# **MODIFICATION APPLICATION PLANNING REPORT (Mod 2)**

## **HILLS SHOWGROUND STATION PRECINCT CONCEPT APPROVAL**

### **HILLS SHOWGROUND PRECINCT EAST**

#### **LANDCOM ON BEHALF OF SYDNEY METRO**

**Figure 2: Proposed Carrington Road Widening (Concept Approval – Approved Architectural Drawings)(COX, 2021)**

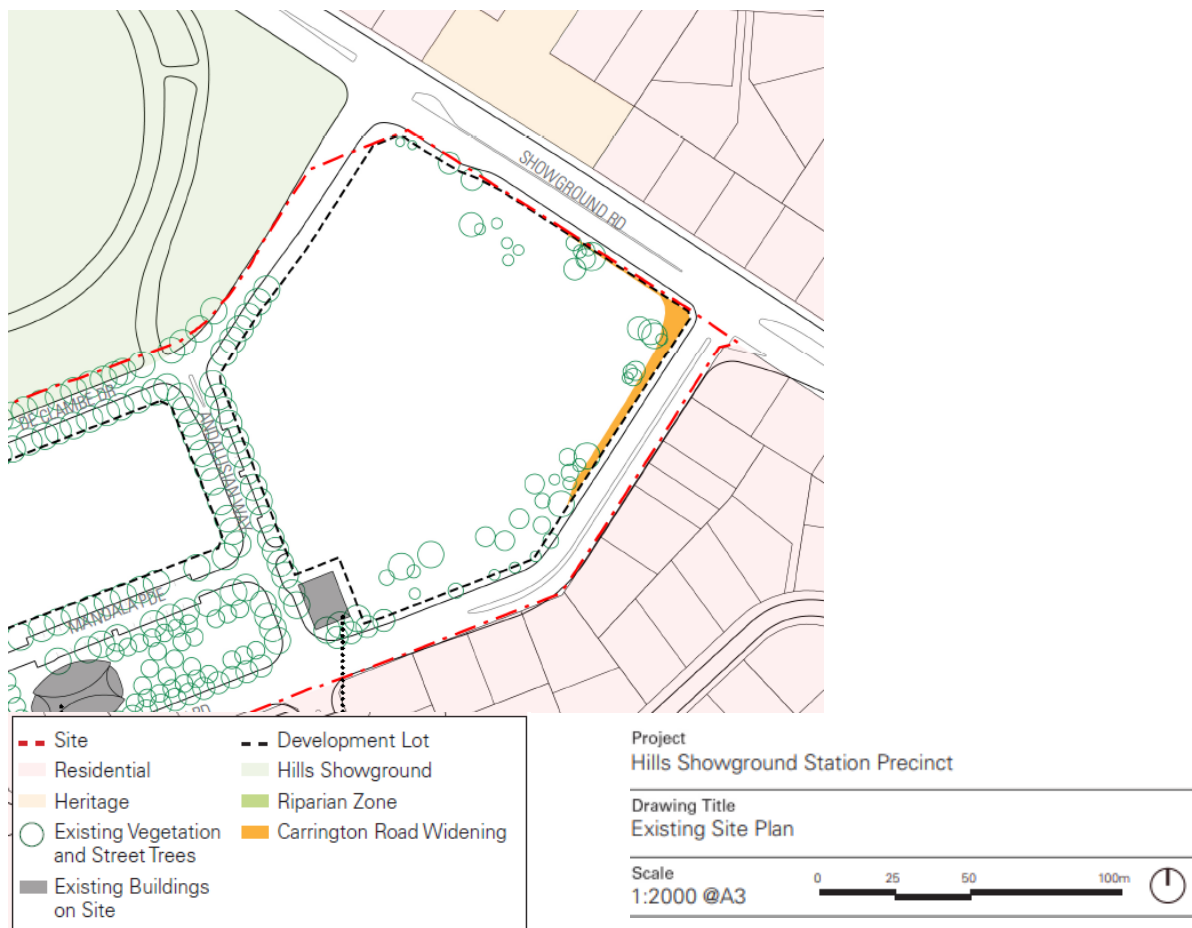
The works to Carrington Road and its intersection with Showground Road are underway and are expected to be completed by mid-2022.

This results in a change to the site area to which the Concept Approval relates.

The additional road widening changes the site boundary for Precinct East by 925m<sup>2</sup> from 2.822 hectares to 2.73 hectares. This results in a change to the subdivision concept referred to in the Concept Approval. An amended subdivision concept is contained in Appendix 3. This affects the size of lots in the concept subdivision plan as discussed in Section 3.1.1.

**Figure 4: Proposed Local Street (COX, 2021)**

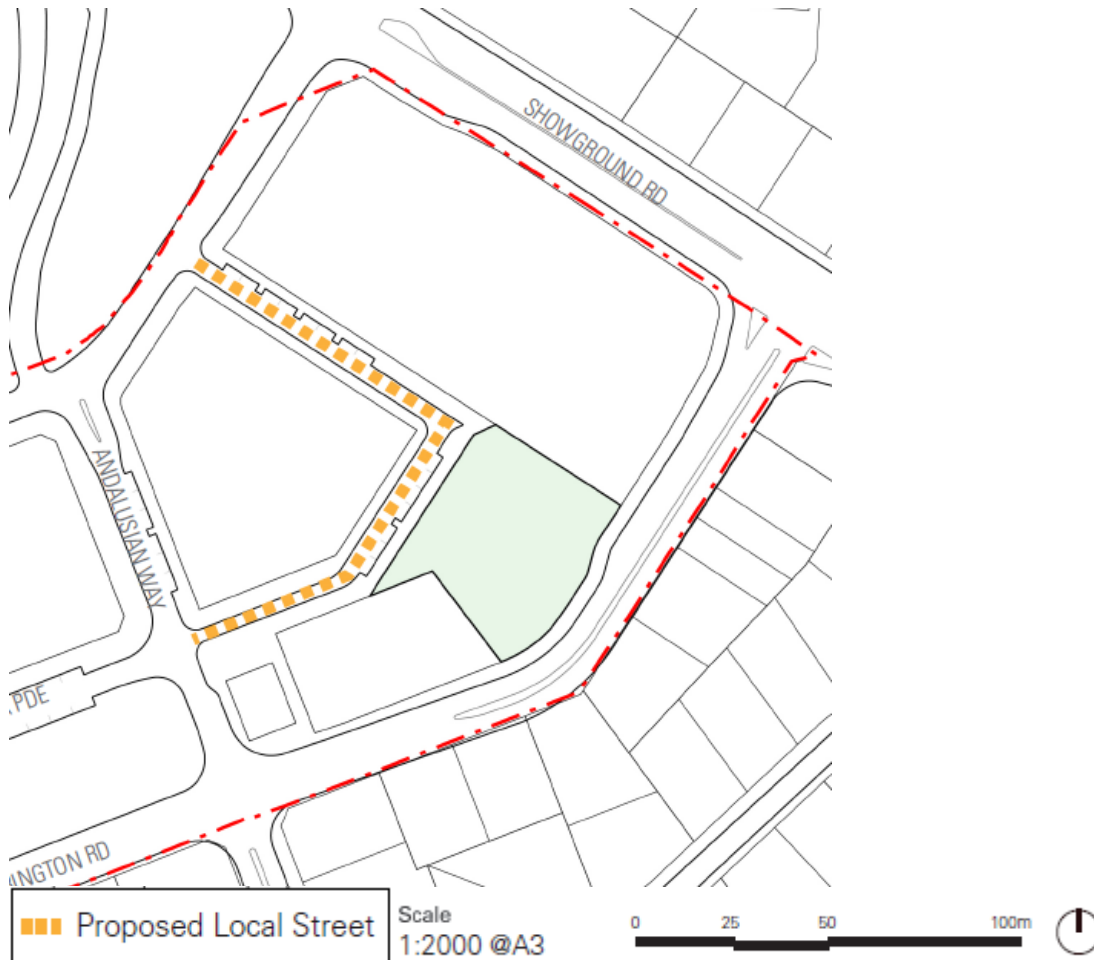
The Concept Approval and associated Urban Design Guidelines envisaged Road No 1 to be two ways in the section from De Clambe Road to the southern end of the proposed park, providing access to future driveways for residential apartments, and then a one way shared zone from the end of the park to Andalusian Way. As a result of further detailed investigations into the access arrangements and public domain design development, in conjunction with consultation with TfNSW and Council, the following access arrangements are now proposed:

- Left in and left out movements at both intersections of the Road No.1 with De Clambe Drive and Andalusian Way;
- Two way movement along the full length of the Road No.1;
- An extended shared zone has been introduced along the frontage of the park extending to Andalusian Way.

The reduced right turn movements at the De Clambe Drive intersection have limited precinct access and necessitated the proposal for the one-way section to be converted to two-way.

The shared zone will provide pedestrian priority and slow traffic movements (10 km/hr) over an extended length of the Road No.1. It provides a calm interface with the park and effectively extends the park edge to include the shared zone. Further, the shared zone enhances pedestrian and cyclist connectivity to the metro station, reinforcing the qualities of a transit-oriented precinct.
